JAFNPP

SAFETY EVALUATION FOR
PROPOSED TECHNICAL SPECIFICATION
CHANGES REGARDING STANDBY LIQUID CONTROL SYSTEM
(JPTS-88-08)

NEW YORK POWER AUTHORITY
JAMES A. FITZPATRICK NUCLEAR POWER PLANT
DOCKET NO. 50-333
DPR-59

FIG. 3.4-1

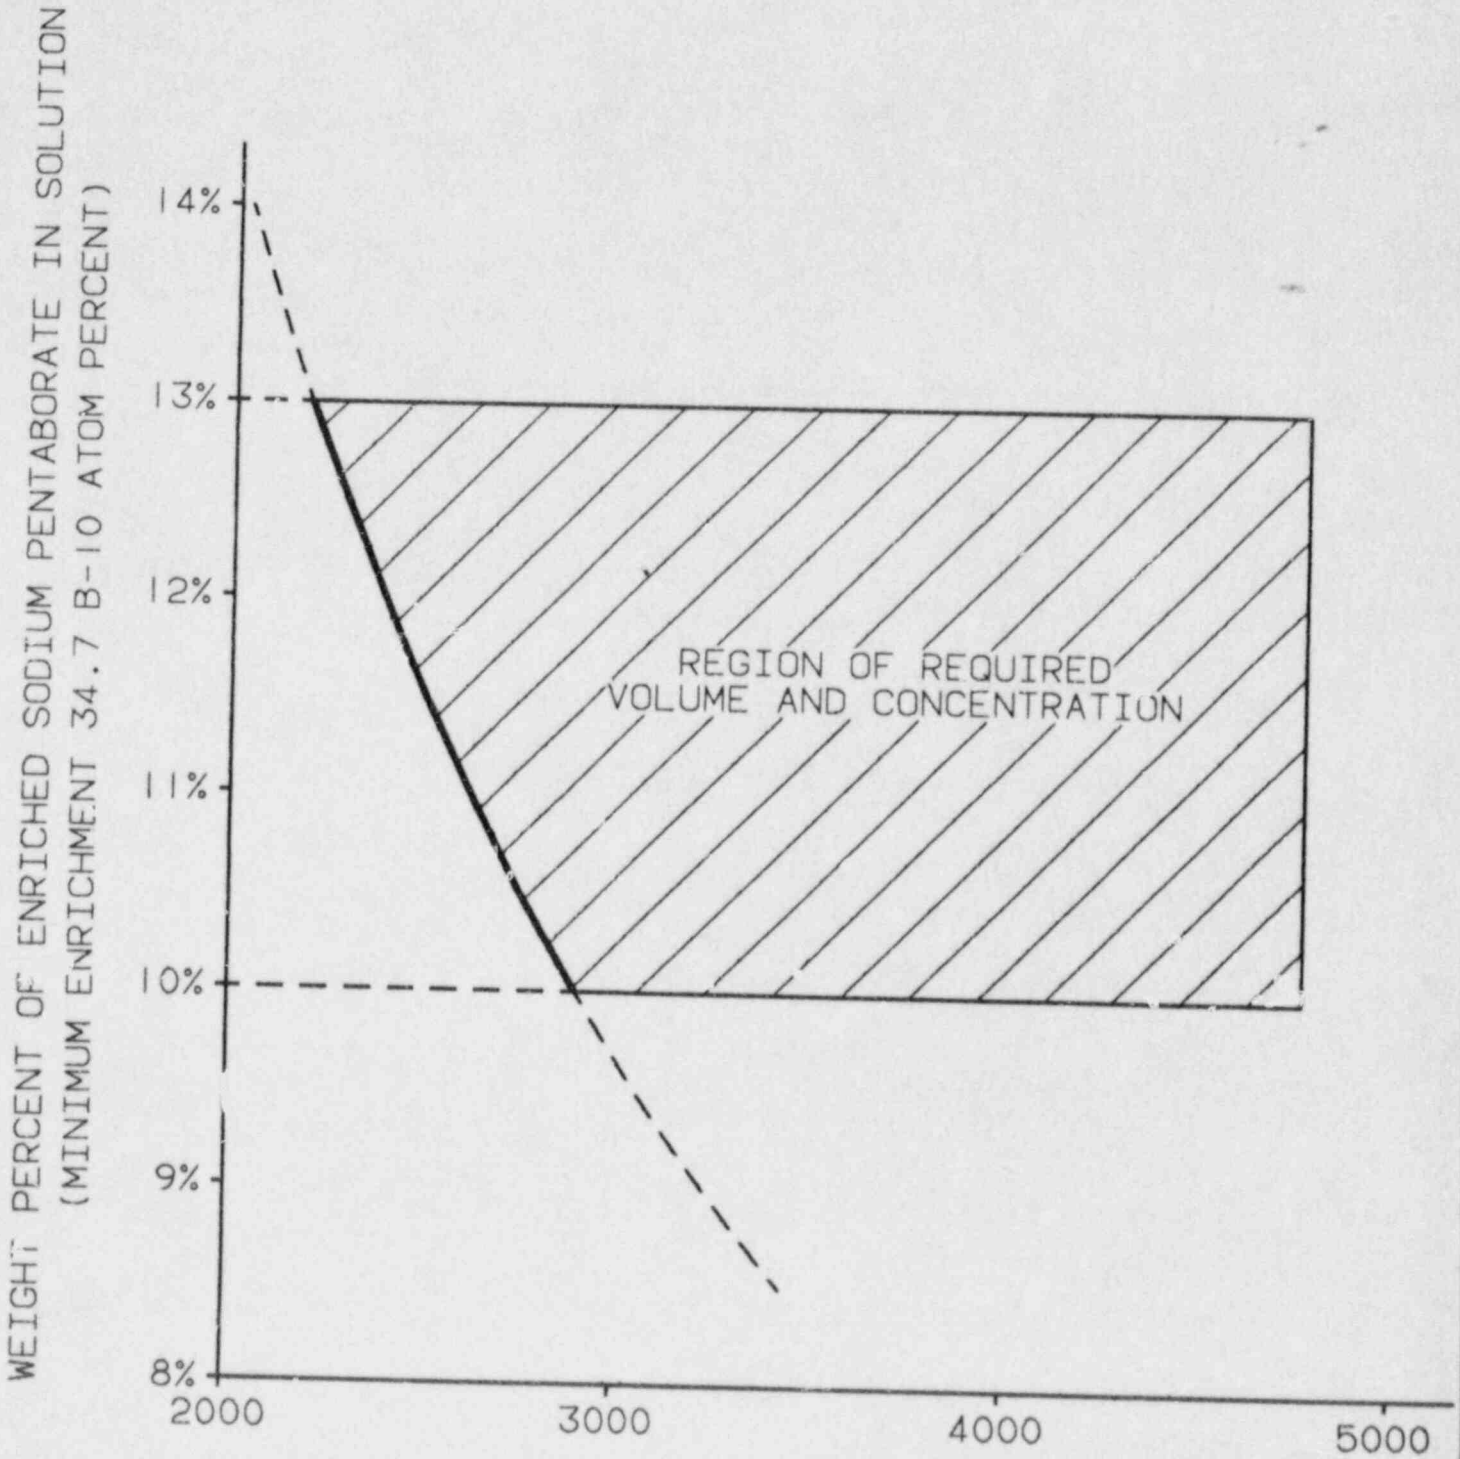
- (g) On page 110, replace Fig. 3.4-1, "Sodium Pentaborate Solution Volume - Concentration Requirements" with new Fig. 3.4-1, "Sodium Pentaborate Solution 34.7 Atom % Enriched Volume Concentration Requirements." This figure is revised to indicate the changes in the region required for volume and concentration of enriched sodium pentaborate solution.

Figure 3.4-1 shows the permissible region of operation on a sodium pentaborate solution volume versus concentration graph. This curve was developed for 34.7% enriched B-10 and a pumping rate of 50 gpm. Each point on this curve provides a minimum of 660 ppm of equivalent natural boron in the reactor vessel upon injection of SLC solution. At a solution volume of 2200 gallons, a weight concentration of 13% sodium pentaborate, enriched to 34.7% boron-10 is needed to meet shutdown requirements. The maximum storage volume of the solution is 4780 gallons which is the net overflow volume in the SLC tank.

FIG. 3.4-2

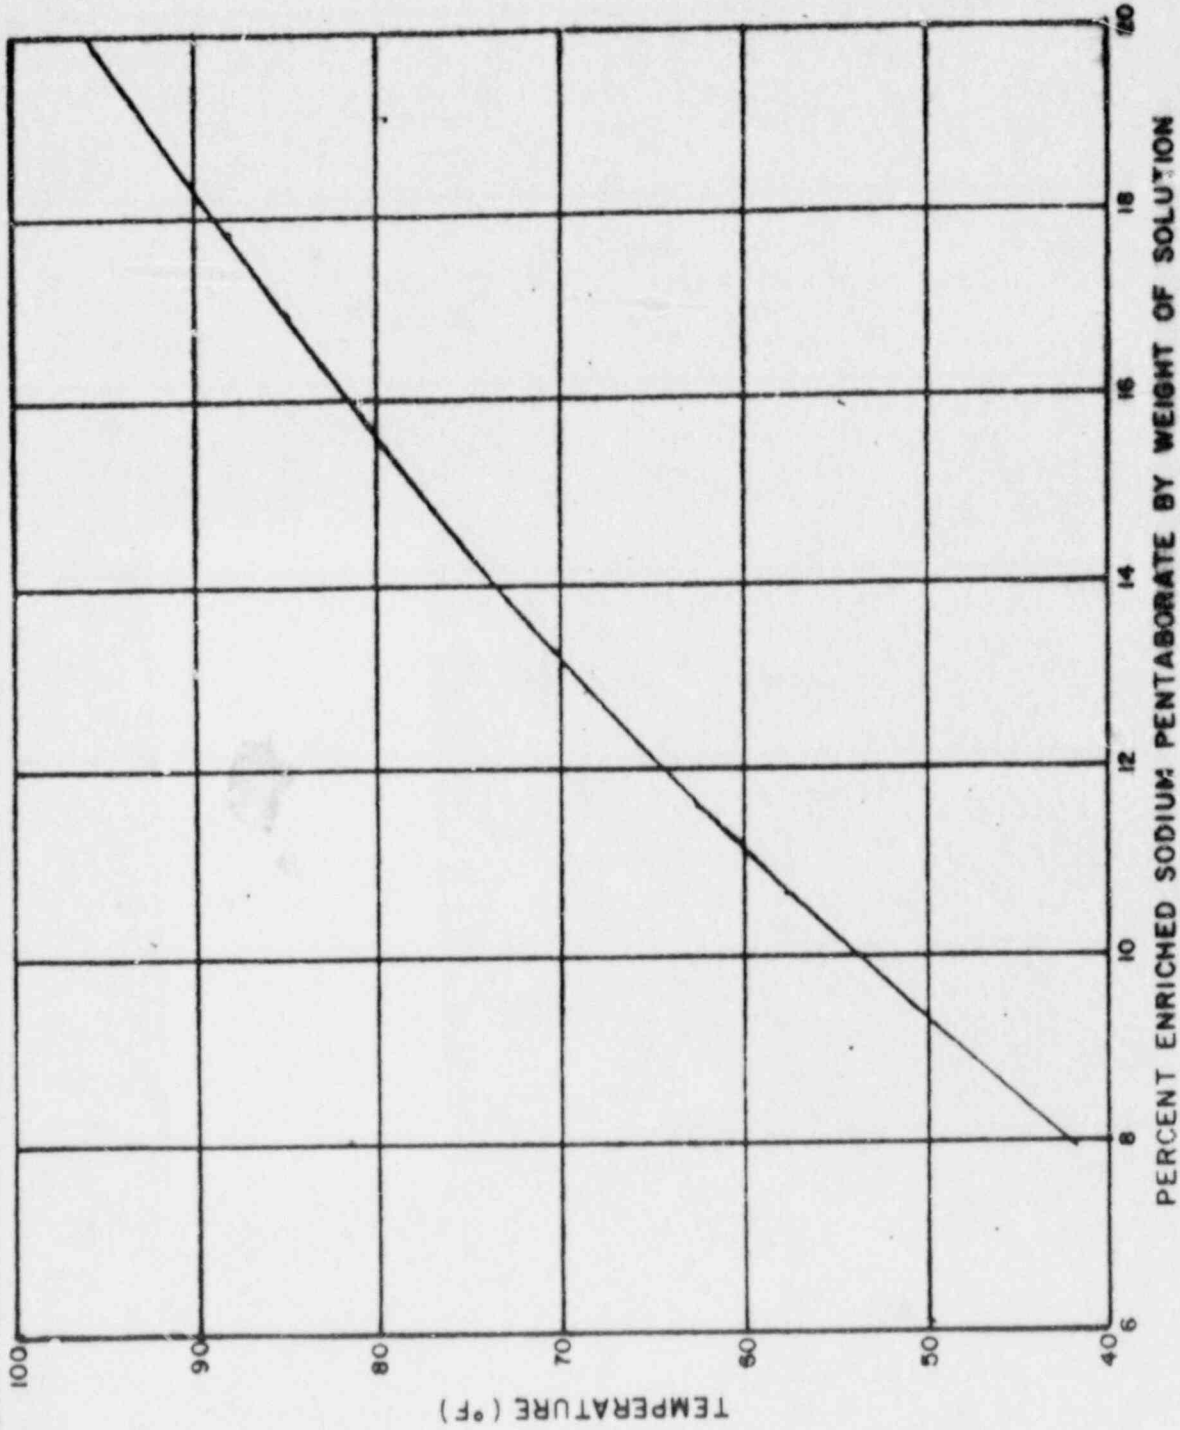
- (h) On page 111, replace Fig. 3.4-2, "Saturation Temperature of Sodium Pentaborate Solution", with new Fig. 3.4-2, "Saturation Temperature of Enriched Sodium Pentaborate Solution (Includes 10°F Margin)."

To guard against precipitation, the solution, including that in the pump suction piping, is kept at least 10°F above saturation temperature. Figure 3.4-2 shows the saturation temperature including 10°F margin as a function of sodium pentaborate solution concentration. Tank heater and heat tracing system are provided to assure compliance with this requirement. The set points for the automatic actuation of the tank heater and heat tracing system are established based on the solution concentration. Temperature and liquid level alarms for the system annunciate in the control room. Pump operability is checked on a frequency to assure a high reliability of operation of the system should it ever be required.
